NIAGARA MOHAWK POWER CORPORATION

AMENDMENT TO PROVISIONAL OPERATING LICENSE

License No. DPR-17
Amendment No. 2

CHANGE NO. 4 TO TECHNICAL SPECIFICATIONS

FIGURE 2.1.2 Revised

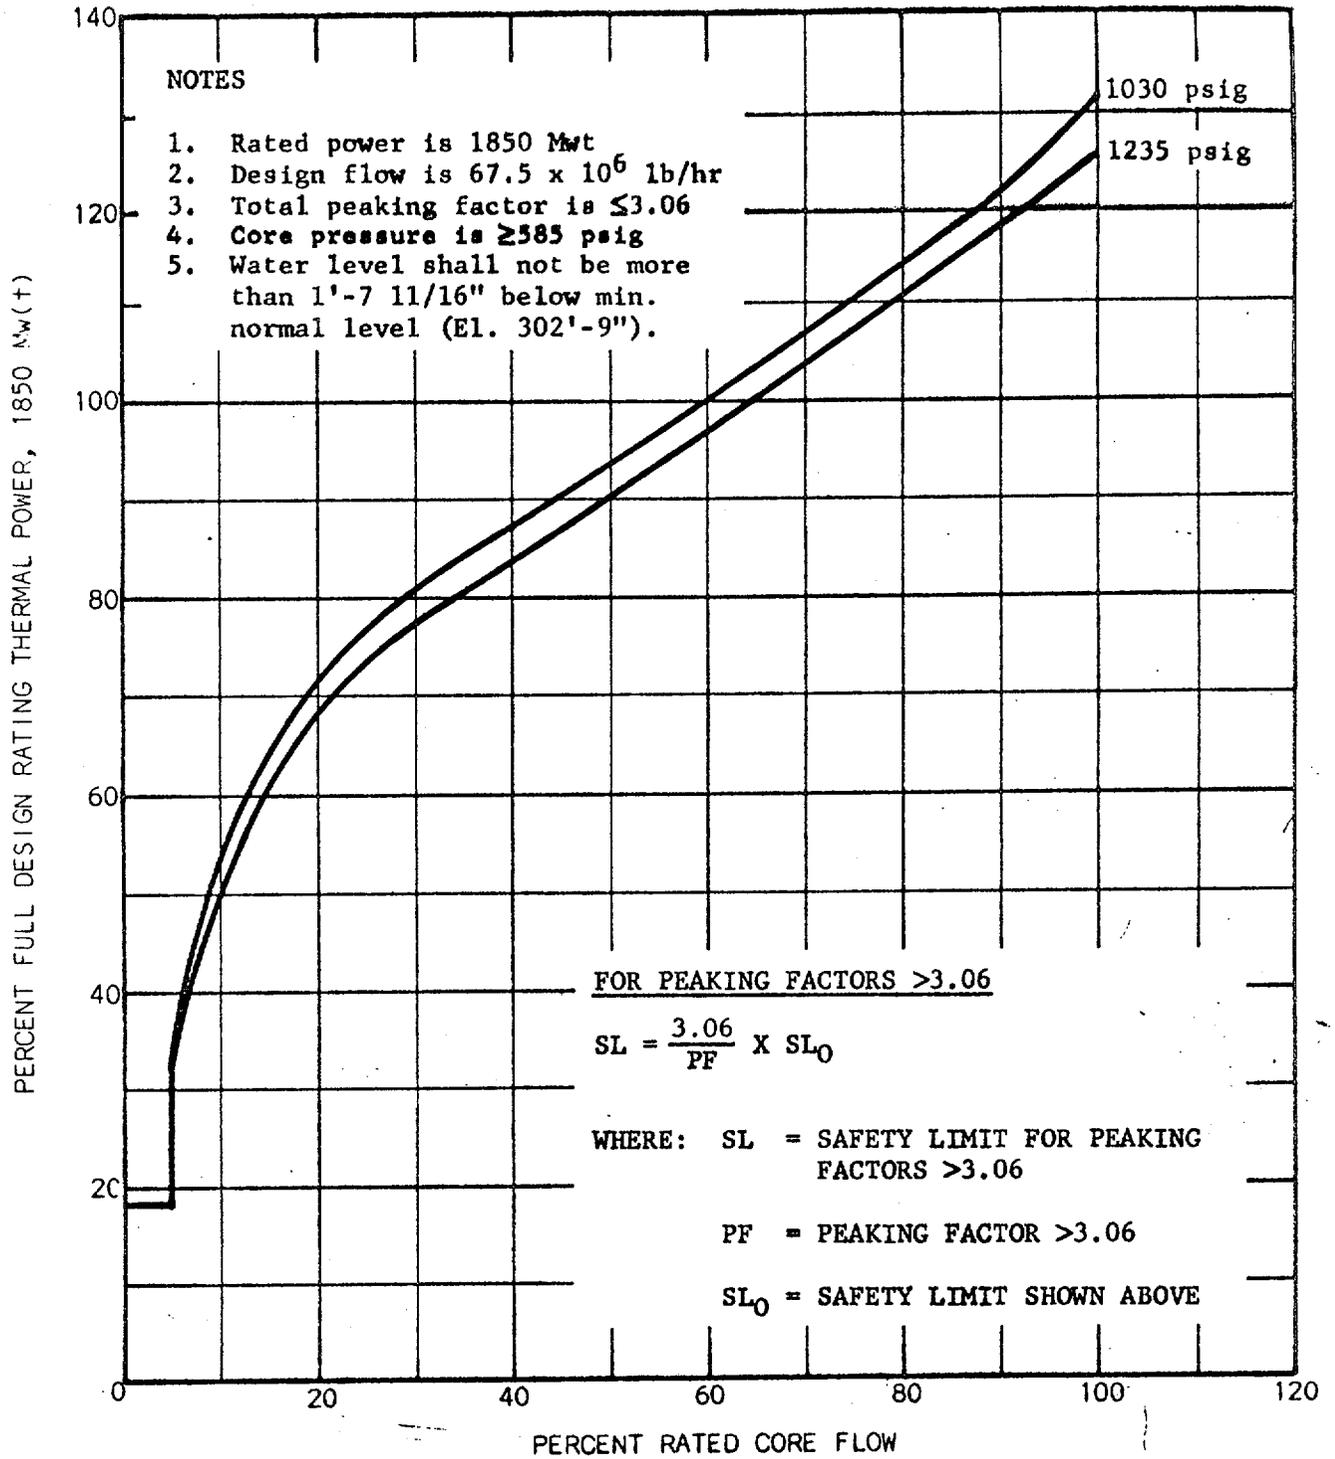
"The thermal hydraulic safety limit of Figure 2.1.1 Revised was based on a total peaking factor of 3.06, and an adjustment is required in the unusual event of higher peaking factors. Likewise, power indication at which scram occurs must be adjusted to assure MCHFRs above 1.0 for expected transients in this derated condition. This is provided by application of the formula on Figure 2.1.2 Revised."

Replace "Figure 2.1.2" with attached "Figure 2.1.2 Revised".

"c. At least daily during reactor power operation, the reactor neutron flux peaking factor shall be estimated and the flow-referenced APRM scram and rod block signals shall be adjusted, if necessary, as specified in Figure 2.1.2 Revised."
